## Executive Summary

CyMod Systems was appointed to undertake an independent review of the numerical groundwater models, which were constructed and calibrated to assess the potential impacts of the proposed K+S Ashburton Salt Project on environmental receptors.

K+S appointed CyMod Systems to undertake an independent review of the numerical groundwater model of the area proposed for the Ashburton Solar Salt Operations. The model was constructed and calibrated to assess the potential impacts of the proposed Ashburton Salt Operations on environmental receptors in the vicinity of the development, due to seepage of high salinity water from solar salt ponds.

**Figure 4-1: Soil Classification showing Relationship between Particle Size and Specific Yield (Johnson, 1968)**

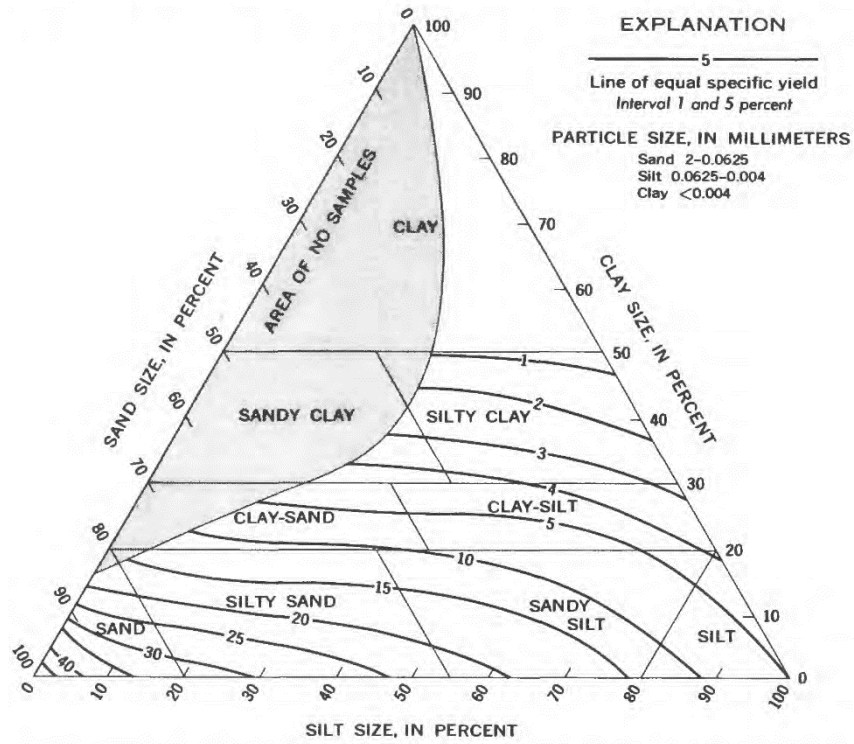
A brief review of estimates of specific yield from particle size distribution of field samples is shown in Table 4-2. Estimates of specific yield have been taken from Figure 4-1 based on silt/clay content measured in soil samples. The data suggests that a specific yield of 0.05 and an effective porosity of 0.10 as suggested in the conceptual model for the 1A/B formation are reasonable but conservative. The limited data for the 2A and 2B formations suggests a low specific yield may also be conservative.

The effective porosity of 0.10 as used in the 1A/B unit is consistent with conservative estimates of these properties, as indicated in the report. The low effective porosity will increase the impact of seepage and EVT, in terms of rate of change in salinity and groundwater level changes.

It is also noted that test pumping of BH7 TB, BH10 TB measured responses primarily in the 2A/B formation and indicated a specific yield of 0.05. It is likely the 1A/B formation will have higher specific yield, given higher sand content.

Figure 1: Mangrove Monitoring - Pilbara, 1990

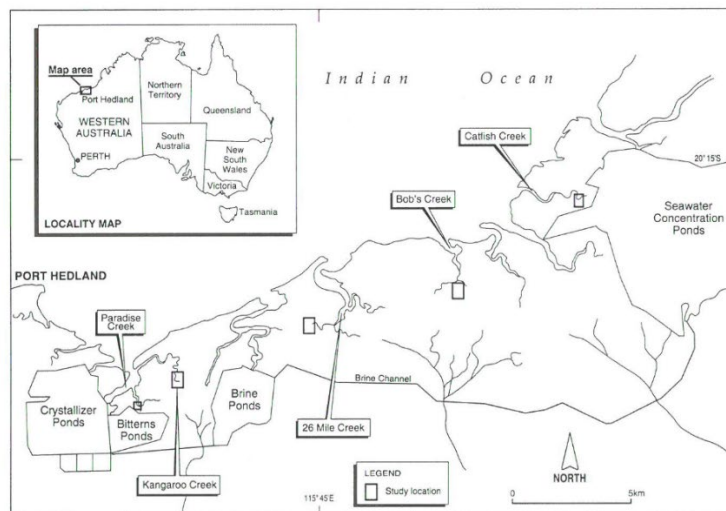
Monitoring undertaken at existing seawater filled ponds (*Gordon, 1988*), show that seepage from seawater filled ponds acts to freshen shallow groundwater immediately outside of the embankment, and cause water levels to rise, resulting in a salt crust. The movement of lower salinity pond water is facilitated by the low EVT that occurs due to the formation of the salt crusts. These salt crusts are common on salt lakes and supratidal flats. As summarized in the abstracts by Chen and Hollins, salt crusts can reduce EVT by 98% in the absence of rainfall and inundation, compared to freshwater evaporation rates. Rainfall and inundation cause a short term increase in evaporation, until a new salt crust is established. Based on this analysis it is likely that the naturally salt encrusted supratidal flats evaporation is less than 300 mm/year in most areas, compared to the calibrated model EVT over most of the model area of 1100 mm/year. This suggests that EVT will not act to trap high salinity pond leakage as concluded in the report, but instead, in the absence of significant EVT, pond seepage water will move laterally (as groundwater) away from the pond, resulting in increasing water levels and freshening of shallow groundwater in the vicinity of ponds.
